**RE: Lot 11& 12 Block 8 Unit 5 SAD 227  
6104 Casablanca NW & 8023 Monte Carlo NW  
Grading and Drainage Plan  
Engineers Stamp Date 4/16/19 (E10D061)  
Pad Certification Date 4/16/19**

RE: **Lot 11 & 121 Block 8 SAD 227**  
**Unser Cliffs**  
**6104 Casa Blanca & 8023 Monte Carlo NW**  
**Grading and Drainage Plan**  
**Engineers Stamp Date 3/29/19 (E10D061)**

Based upon the information provided in your submittal received 3/28/19, this plan cannot be approved for Grading Permit until the following comments are addressed.

ENGINEER'S SEAL  4/16/19	6104 CASA BLANCA	DRAWN BY: WCUJ
	GRADING AND DRAINAGE PLAN	DATE: 3-29-19
 1606 CENTRAL AVENUE SE SUITE 201 ALBUQUERQUE, NM 87106 (505) 872-0998		2109029-LAYOUT-3-29-19
		SHEET #
DAVID SOULE P.E. #14522		JOB # 2109029

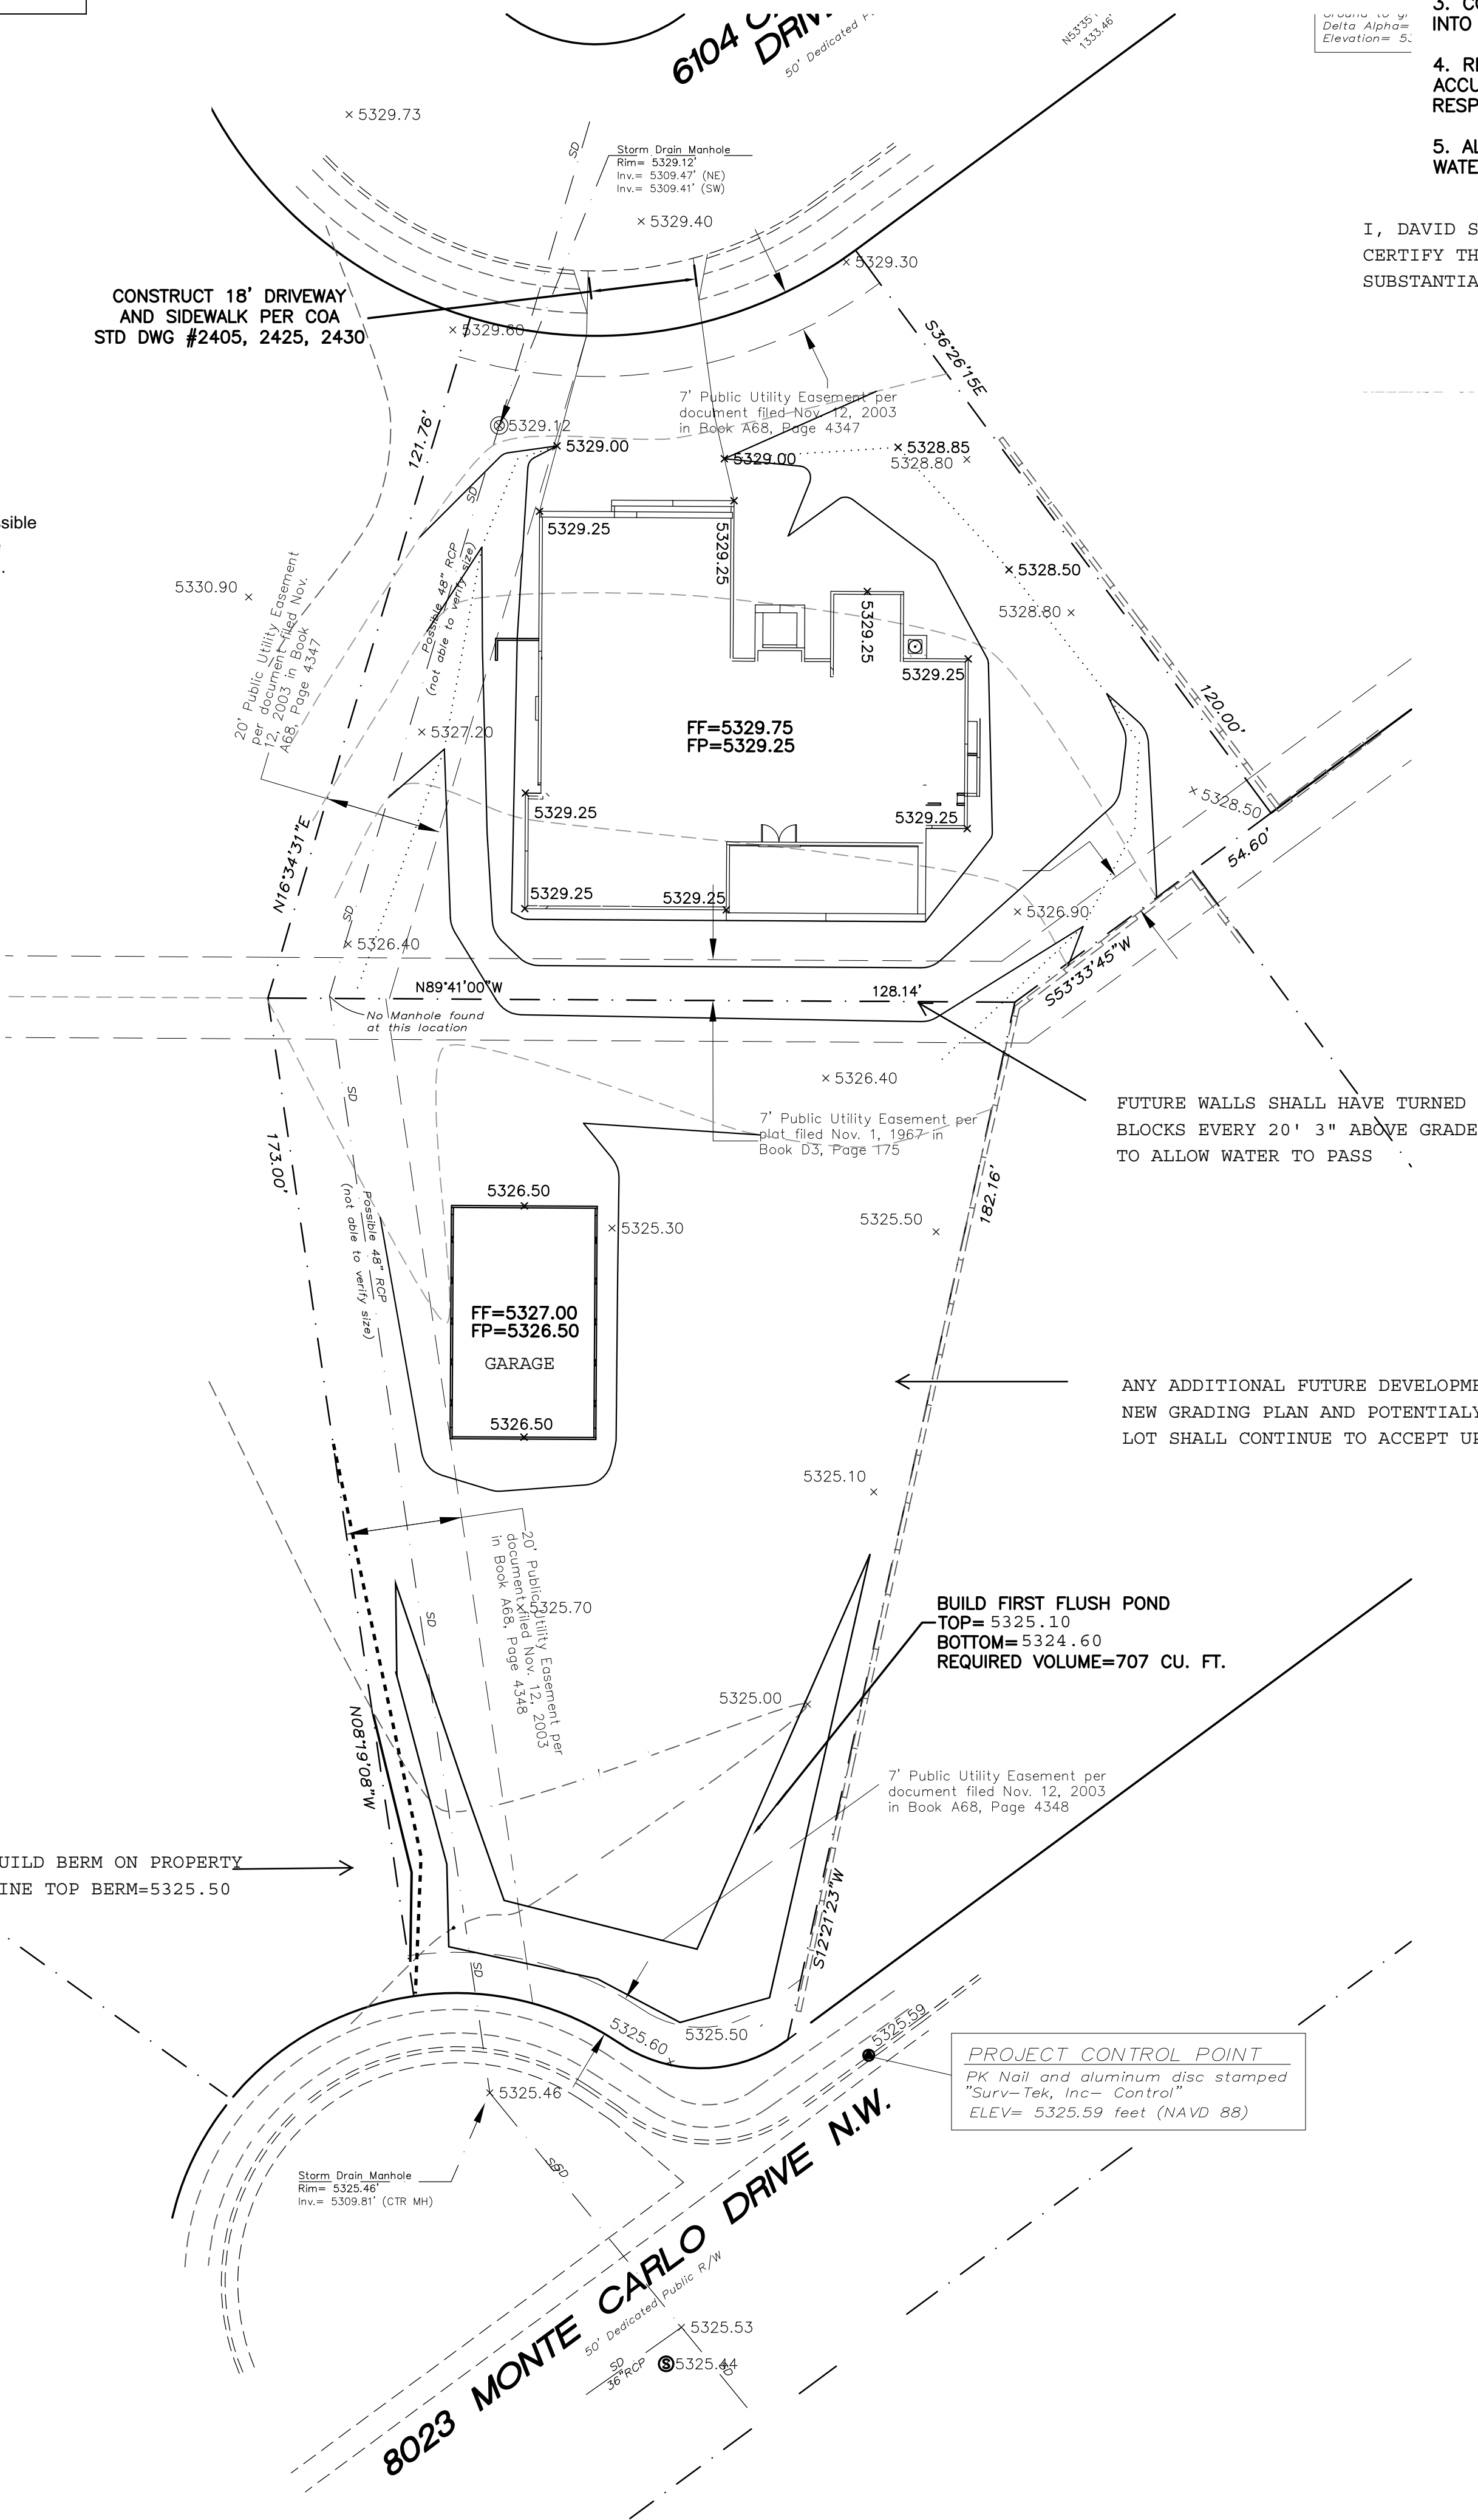
- Provide a detention pond for the site. The percentage required is 34%, the amount of D provided is 55%, the pond must contain the difference which is 21% or provide a statement that flows will be allowed to travel south onto 8023 Monte Carlo. If a cmu/garden wall is placed between the two lots openings will be placed to allow these flows to continue. **ADDED NOTE . WE TREATED LOT AS ONE SINCE THAT IS HOW OWNER WANTS TO DEVELOP THEREFORE THE 19%D.**

Prior to Building Permit approval a pad certification is required.

**PAD HAS BEEN GRADED SO WE ARE CERTIFYING PAD ALSO**
